URGENT FIELD SAFETY NOTICE

FSCA Reference: 1427918 - Bubble Sensor - Bad contact in sensor cable

Affected Product: BS 3/8x3/32 L1.7 Mat. 701055720
(Bubble Sensor for 3/8" x 3/32" tubing, length 1,7 m)

Figure 1 Picture of a Venous Bubble Sensor

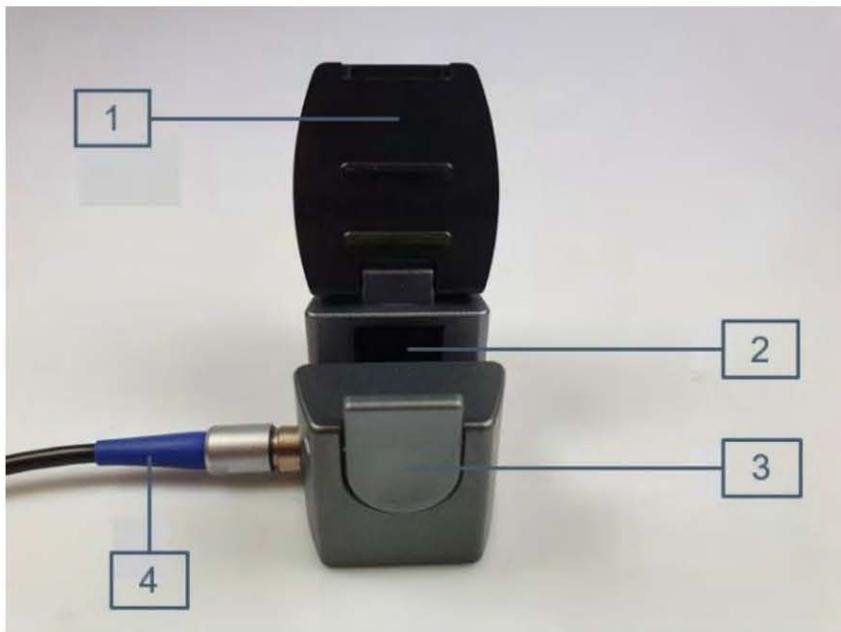
Internal investigations have identified an issue with the durability of the connecting cable (See Fig. 1 position [4]) near the connection to the Bubble Sensor. Excessive bending of the cable can lead to poor contact, which may trigger the errors "Ven. bubble sensor defective" or "Ven. bubble sensor disconnected" on the connected medical device (ROTAFLOW II or CARDIOHELP-i). These errors can occur temporarily when the cable is moved or permanently if the connection is fully compromised.

- **The Venous Bubble Sensor remains functional until error** ("Ven. bubble sensor defective" or "Ven. bubble sensor disconnected") displays on the main device.
- **To prevent error occurrence please follow these guidelines when handling Venous Bubble Sensors:**
 1. **Avoid roll up or coiling of the sensor cable!** When storing affected products, place them loosely in a box or bag to prevent damage.
 2. **Avoid excessive bending** of the Venous Bubble Sensor.
 3. **Handle the Sensor cable with care during cleaning.** Do not pull with excessive force while wiping the cable.

Replacement of affected with unaffected devices.
